**Planning, Zoning & Economic Development  
Memorandum**

**DATE:** November 17, 2020

A. Project Name / Number: 8601 W. Sunrise Redevelopment / PP20-0016

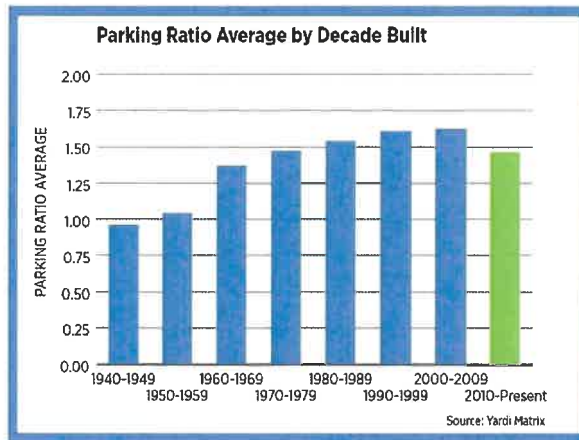
**To (Staff):** Reduce the required setbacks from 94.9' for the residential buildings to 63.1' on the west side of Building 1 and 73.4' on the south side of Building 3. Reduce the required setback from 99.8' for the office building to 28.9 feet on the east side.

**Applicant justification:** The Code would require our setbacks to be 96'-0" which would have a substantial impact on the amount of buildable space and park area the Applicant would be able to provide. With this waiver, a larger green area and a larger amenity area can be provided. Additionally, parking ratios, pedestrian walking paths, amenity areas, and circulation would also be negatively impacted if the Applicant was required to meet the Code.
